Access Compliance Report Public Rights-of-Way (Curb Ramps)

Main Street: BRADBURY_RD Cross Street: MONTECITO_RD Location: SE

ADA ID: RPRK211209131123 Ramp Type: Type 1 - Perpendicular Diagonal Initial Pass/Fail: Fail Overall Compliance: No Severity Score: 2

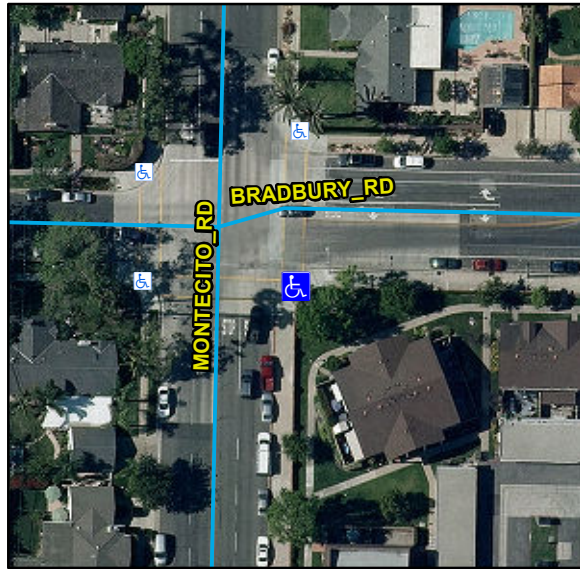
Compliance	Description	Data	Compliance	Description	Data
N/A	Ramp Length (in)	65	N/A	Flare Type LT	
Yes	Ramp Width (in)	48			N/A
Yes	Ramp Run Slope (%)	6.1	N/A	Flare Slope LT (%)	N/A
No	Ramp Cross Slope (%)	2.1	N/A	Flare Traversable LT	N/A
N/A	Landing Present	N/A	N/A	Flare Type RT	
N/A	Landing Length (in)	N/A			N/A
N/A	Landing Width (in)	N/A	N/A	Flare Slope RT (%)	N/A
N/A	Landing Run Slope (%)	N/A	N/A	Flare Traversable RT	N/A
N/A	Landing Cross Slope (%)	N/A	N/A	DWS Provided	N/A
N/A	Landing Movement Obstructed?	N/A	N/A	DWS Contrast	N/A
	Landing Movement Type	N/A	N/A	DWS Length (in)	N/A
N/A	Landing Shared	N/A	N/A	DWS Full Width	N/A
N/A	Clear Space	Yes	N/A	DWS Offset Left (in)	N/A
N/A	Clear Space To Crosswalk (in)	48	N/A	DWS Offset Right (in)	N/A
N/A	Marked Crosswalk 1	Yes	N/A	Marked Crosswalk 2	Yes
	Crossing 1 Direction	N		Crossing 2 Direction	W
	Marked Crosswalk 1 Width (in)	144		Marked Crosswalk 2 Width (in)	144

N/A	Ramp Inside Crosswalk 1	Yes	Yes	Ramp Inside Crosswalk 2	Yes
	Crossing 1 Slope (%)	2.1		Crossing 2 Slope (%)	0.7
	Crossing 1 Cross Slope (%)	1.1		Crossing 2 Cross Slope (%)	4.2
N/A	Gutter Ponding	N/A	N/A	Curb Slope	3.3
Yes	Gutter Lip Height (in)	0		Road Run Slope (%)	1.9
N/A	Gutter Run Slope (%)	N/A		Road Cross Slope (%)	0.7
N/A	Gutter Cross Slope (%)	N/A			
Yes	Overall Surface Condition: Acceptable		Yes	Perp Joint Present	Yes
	Cross Gutter Present?	Yes		Spandrel Present?	Yes
	Replace Cross Gutter?	No		Replace Spandrel?	No

Remove & Replace Curb Ramp With Two New Directional Ramps or Equivalent.

R304.5.3, STD 1115
